ENCLOSURE 1

Marked-up Pages of RBS Tech. Specs. for Requested Changes

Subject: REVISION OF RIVER BEND P-T CURVES REPORT SASR 89-20

FIGURE 3.4.6.1-1
MINIMUM TEMPERATURE REQUIRED VS REACTOR PRESSURE

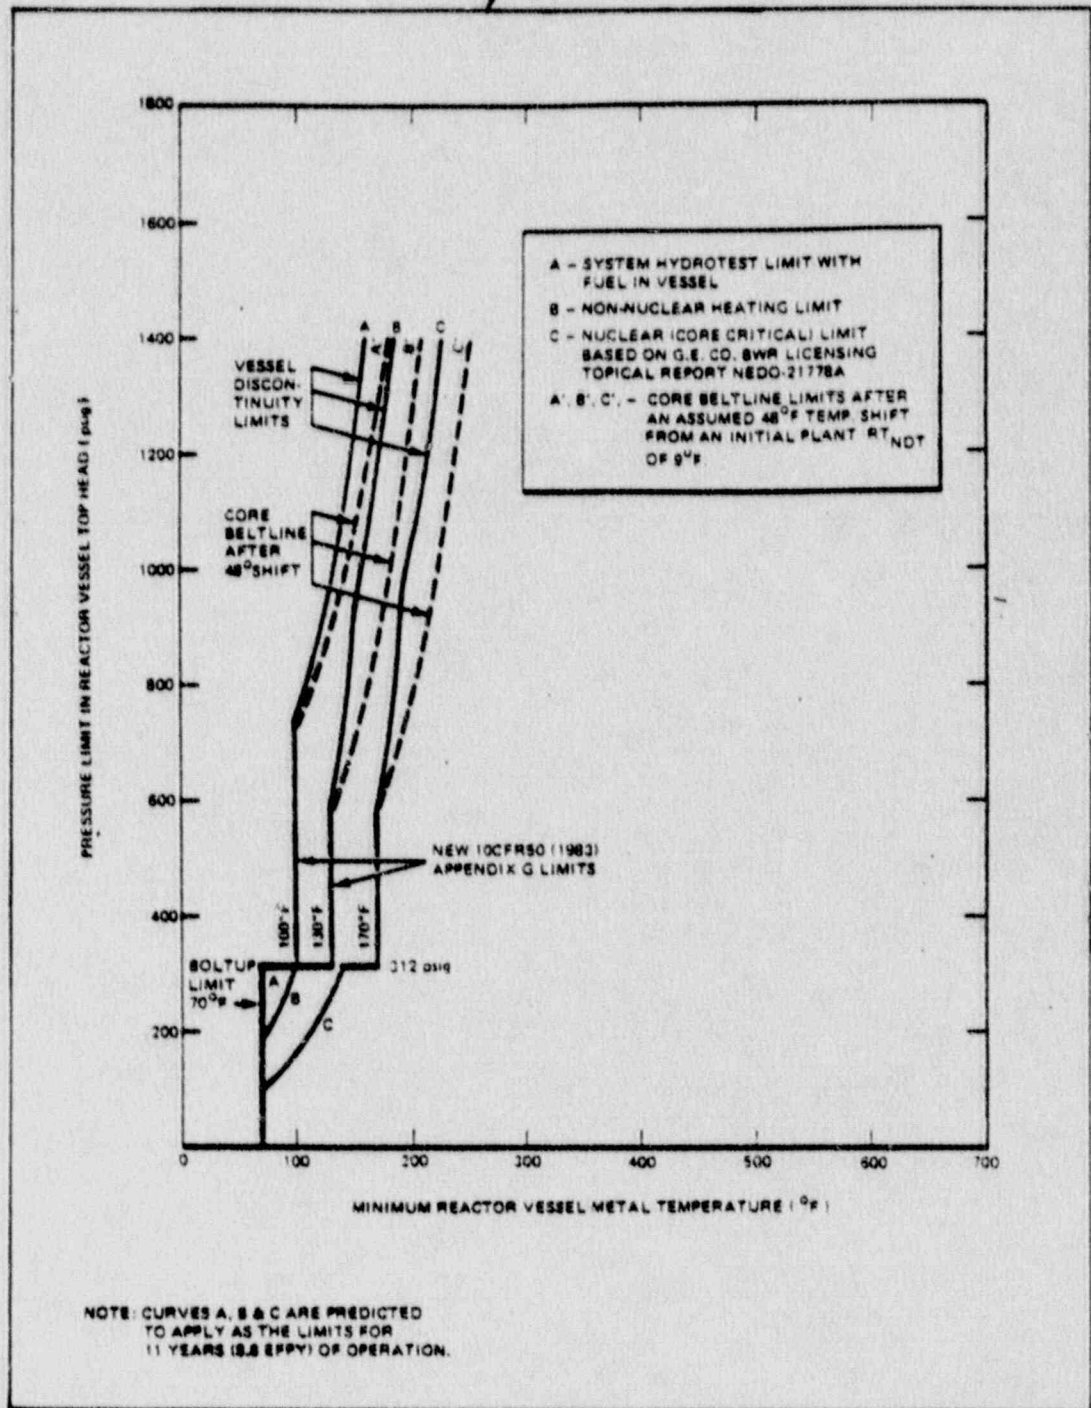
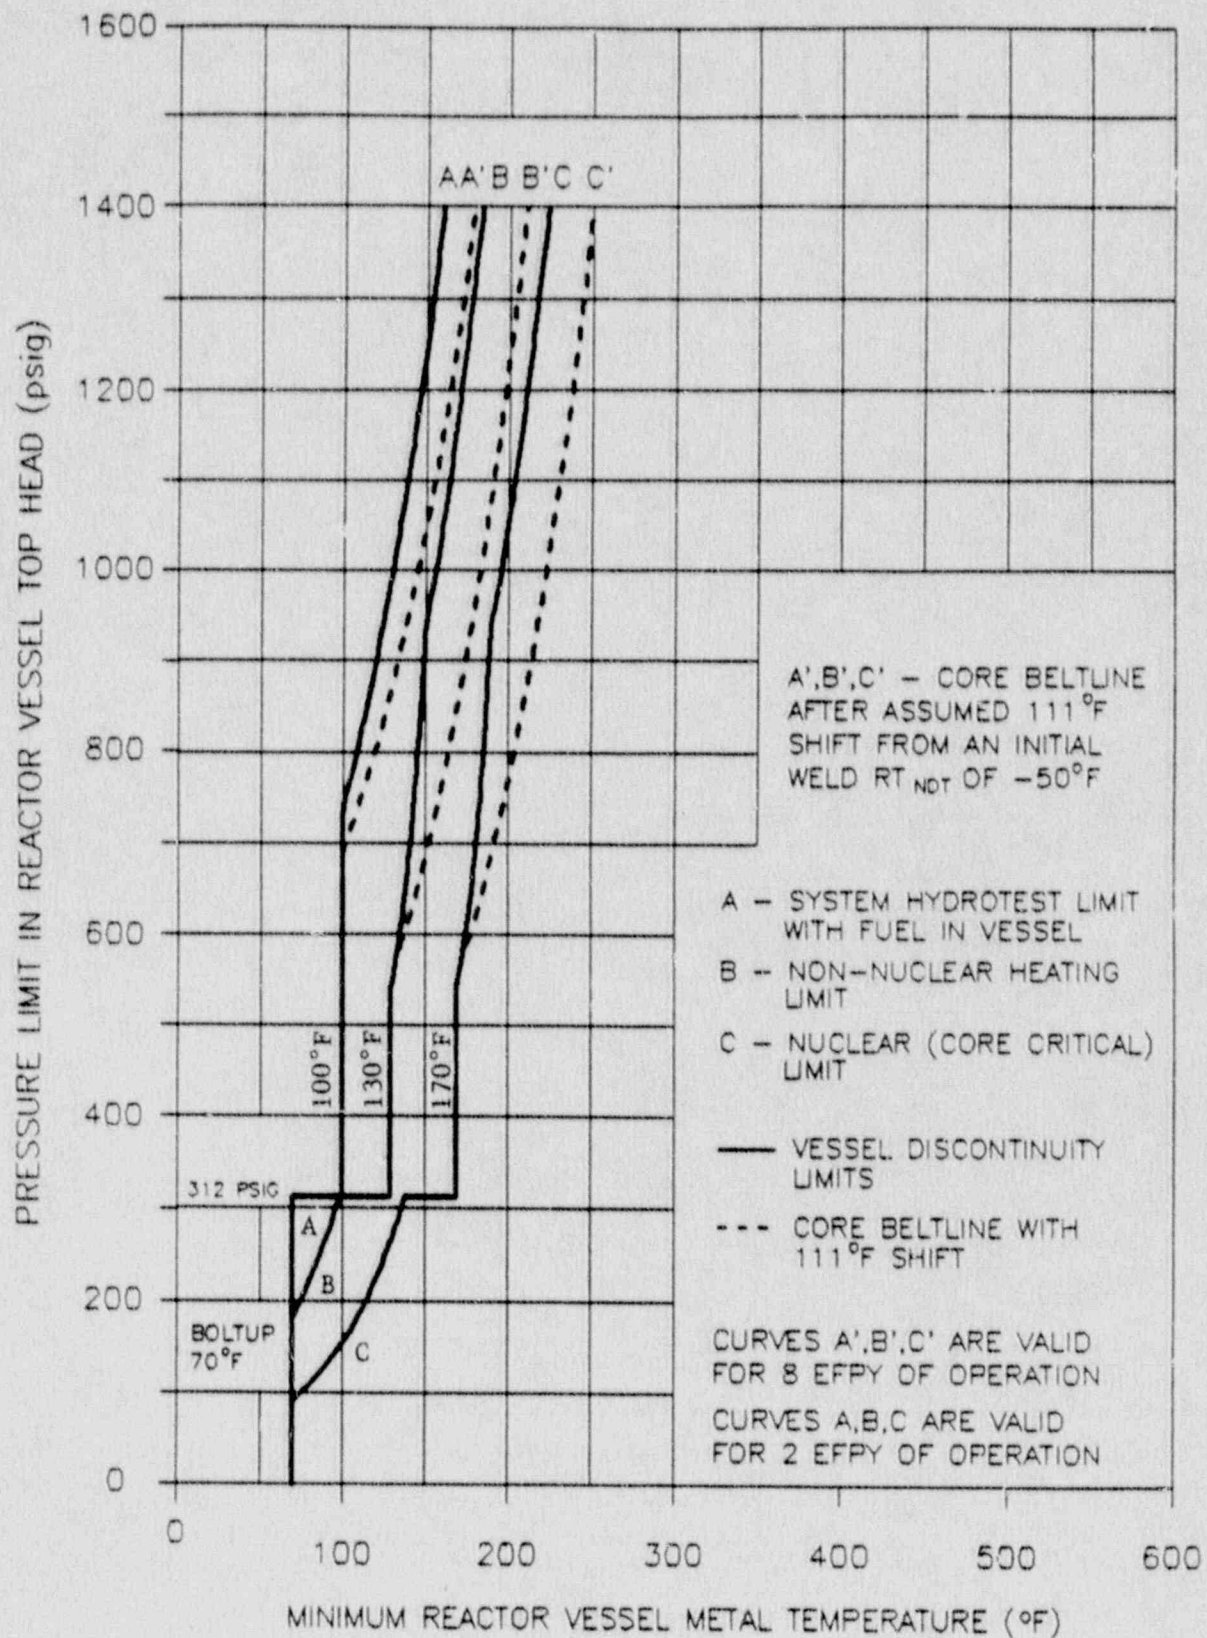
Replace with revised
Figure 3.4.6.1-1

As we have discussed by phone, the thickness 5.81 inches used in calculating previous P-T curves, including those in Reference 2 and those currently in the Tech Specs, was incorrect. Reference 1 is based on the correct value of 5.41 inches. The most significant change in Reference 1 compared to Reference 2 is that the P-T curves A', B' and C' have increased by about 7°F.

BASES FIGURE B 3/4.4.6-1
FAST NEUTRON FLUENCE (E>1 MEV) AT 1/4 T AS A FUNCTION
OF SERVICE LIFE*

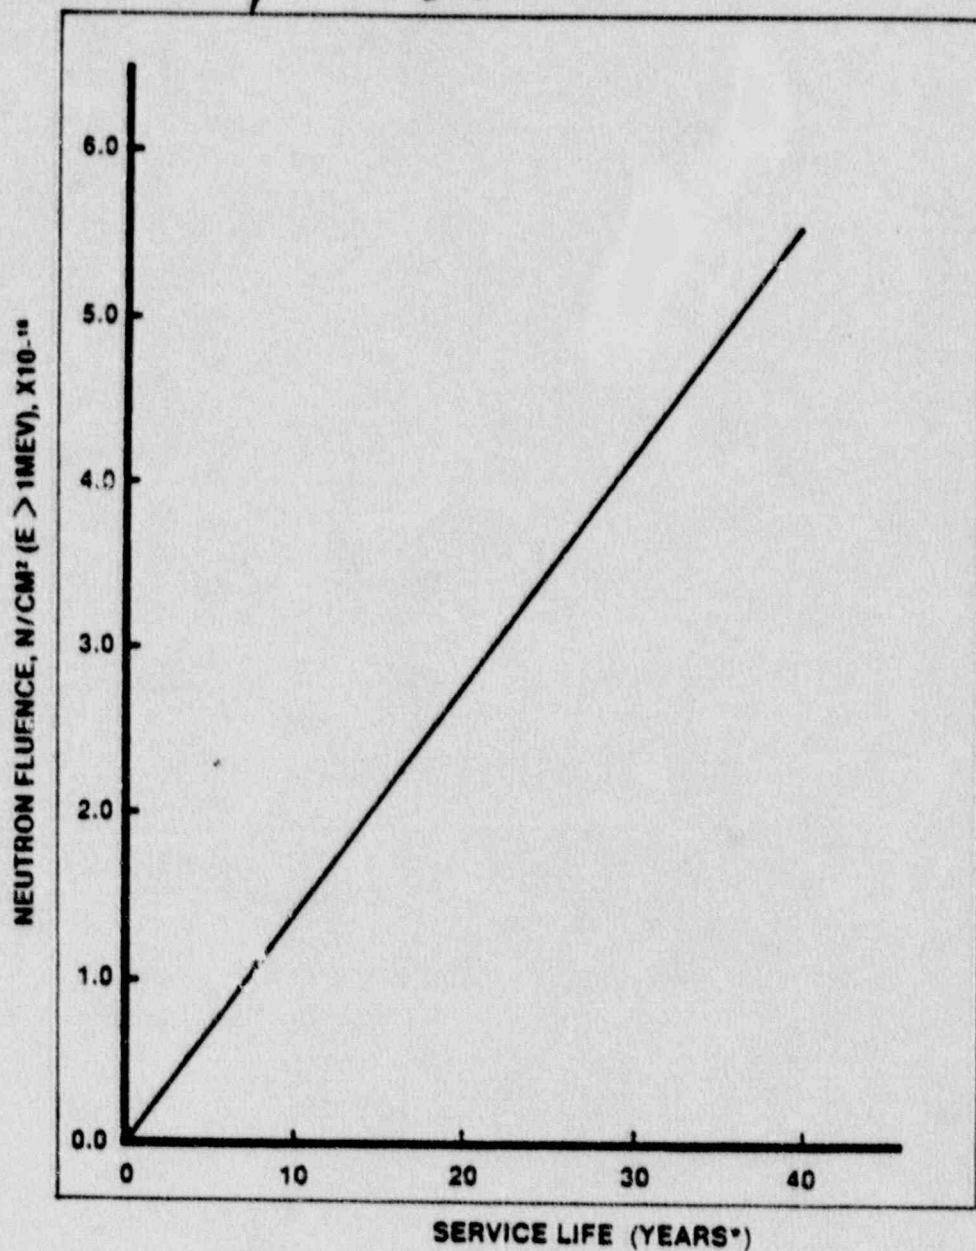
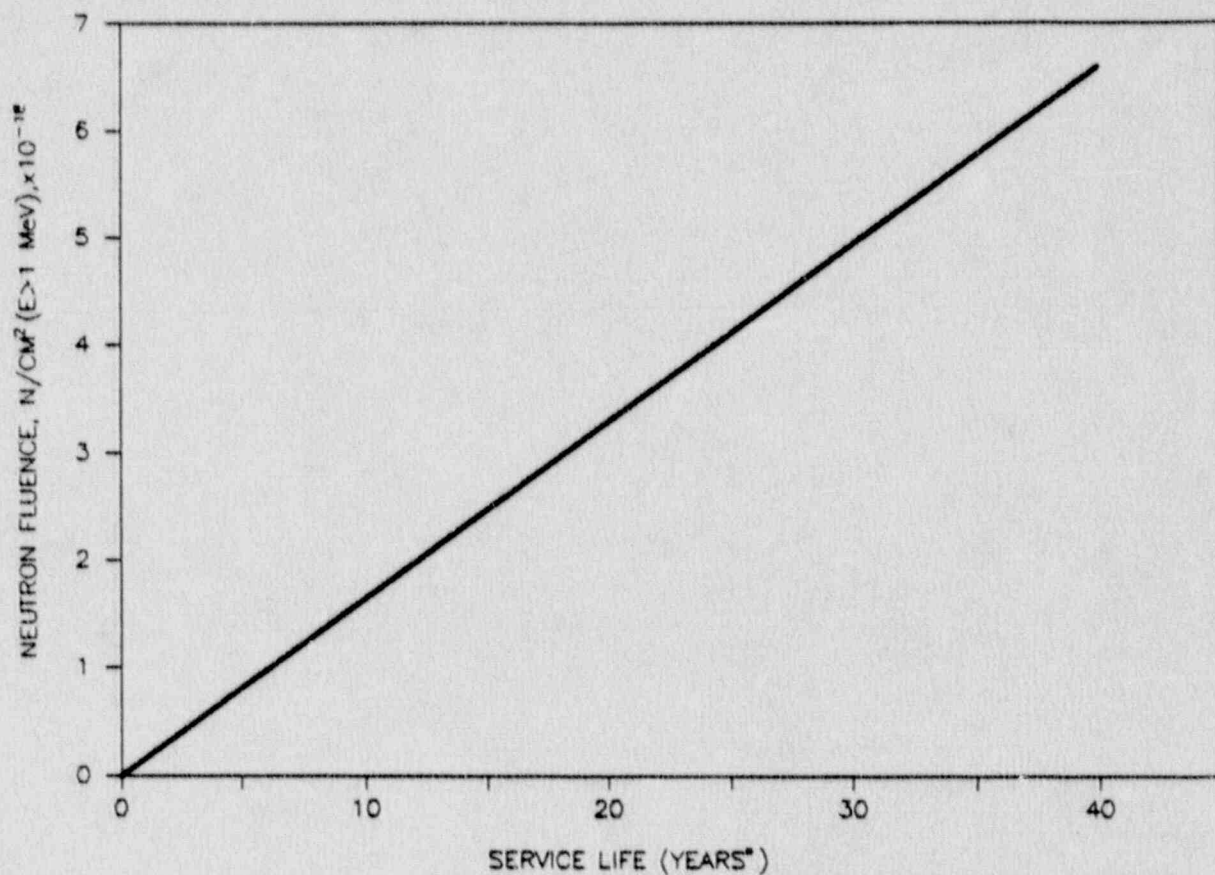
Replace with revised
Figure B 3/4.4.6-1
